Proposed Sections

2021 Planning Permission

Proposed Section 73 Amendment

To be read in conjunction with Addendum Transport Statement by Motion.

00
Ground Floor

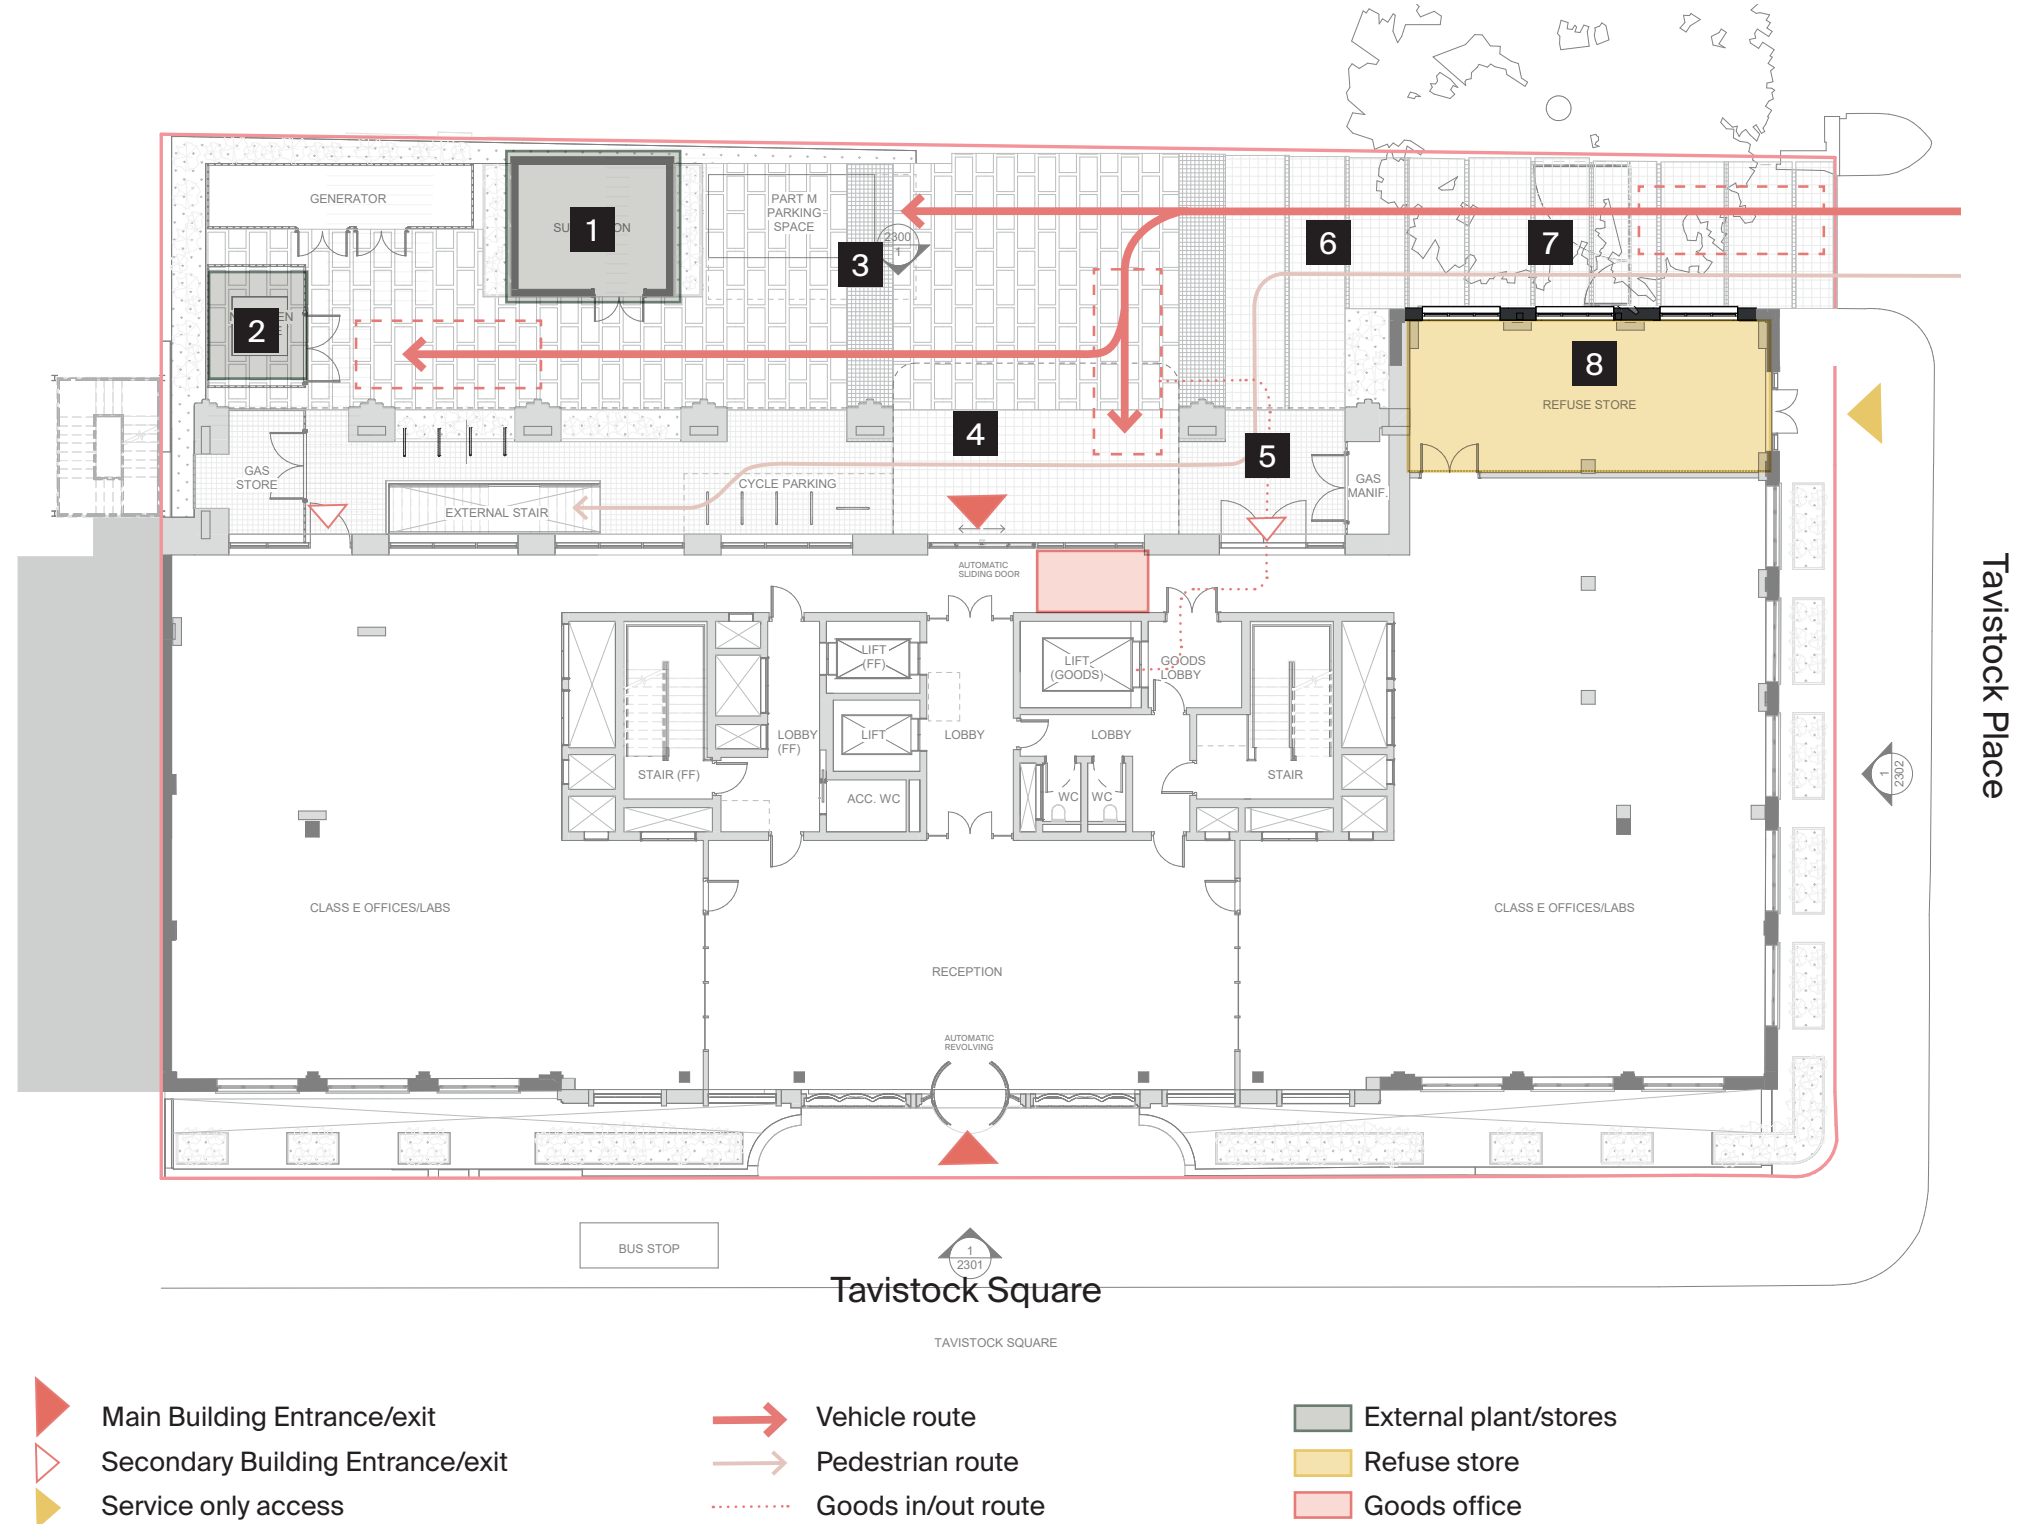
The proposed development will provide long-stay and short-stay cycle parking provision in line with the London Borough of Camden CPG and London Plan (2021) standards for Light Industry/Research (B1), with flexibility to expand to Office Use (E) in future.

The long-stay cycle provision will be located in the basement and enhanced by the provision of showers, changing facilities, vanity space, drying room and lockers provided adjacent to the cycle parking area. A minimum of 5 showers will be provided, with spatial allocation available for up to 9.

The short stay provision will include a total of 9 spaces, with one for adapted bikes at ground level to the rear of the building.

Long Stay Spaces: 36

Short Stay Spaces: 9

Transport Strategy

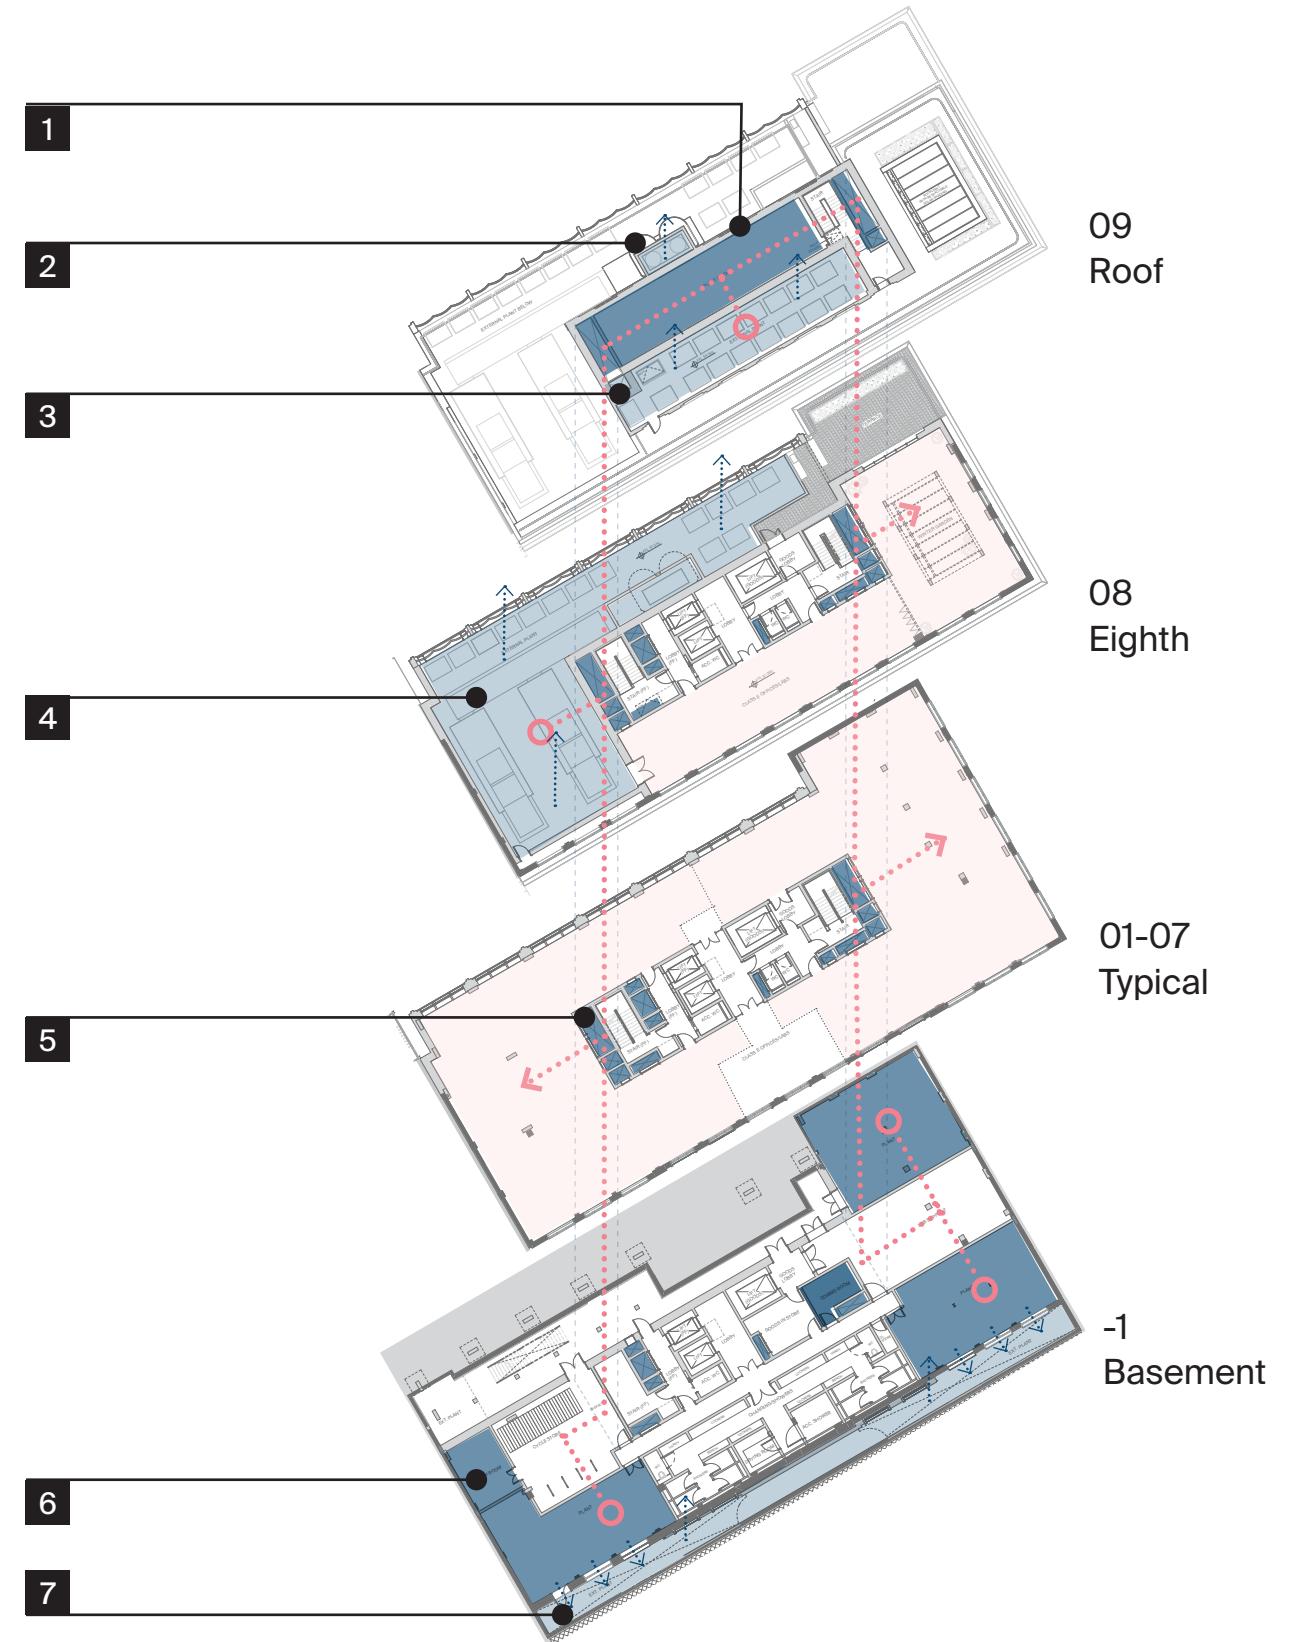
The transport strategy follows the same principles as the permitted scheme with minor adaptations for the additional servicing required within the yard.

- 1 UKPN substation expanded and relocated to allow for generator plant. Brickwork construction to match existing building brick colour. Green walls to north and south facades.

- 2 Nitrogen/Gas storage cylinder and metal enclosure with 6m vehicle access provided for refill and deliveries.
- 3 The development remains car free, with a single space reserved for disabled use

- 4 Existing levels raised to create level entrance
- 5 Loading bay adjacent to dedicated goods entrance, goods office and goods lift. Shared surface provided to slow traffic and mark non pedestrianised space.

- 6 Low risk traffic allows for shared surface and gate opening as per permitted scheme. Dedicated pedestrian/bike paving surface to separate vehicle and foot traffic.

- 7 Gate set back to allow 6m vehicles to wait without overlapping footway
- 8 Refuse store relocated to within building footprint, accessed via main road.

Facade Retention

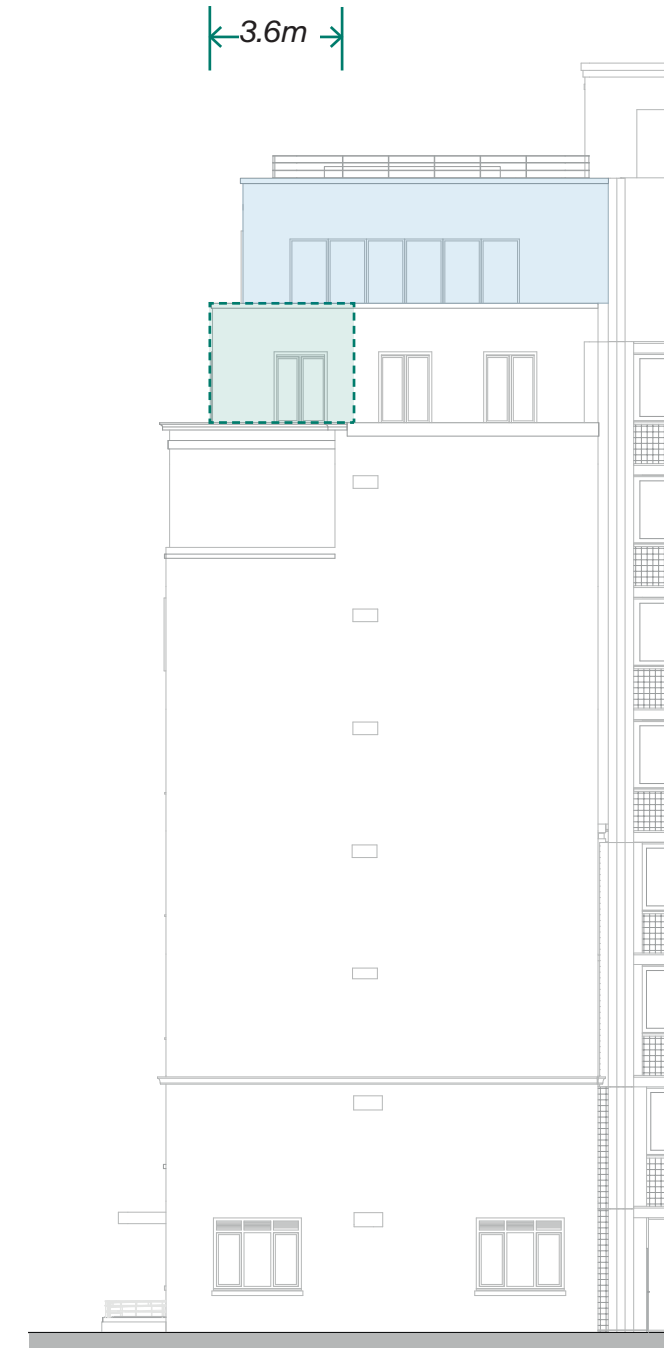
Where the building steps inwards, two options for the temporary solution for the facade during strengthening works have been considered:

Option 1 Facade replacement – 65 tCO2

Option 2 Facade retention – 75 tCO2

Option 1 is a 13% improvement on the full retention option, therefore the proposals include for the removal of the facade during the strengthening works.

The existing bricks are to be salvaged and reused in the reconstruction where possible. Where existing material cannot be reused, matching will be sourced.
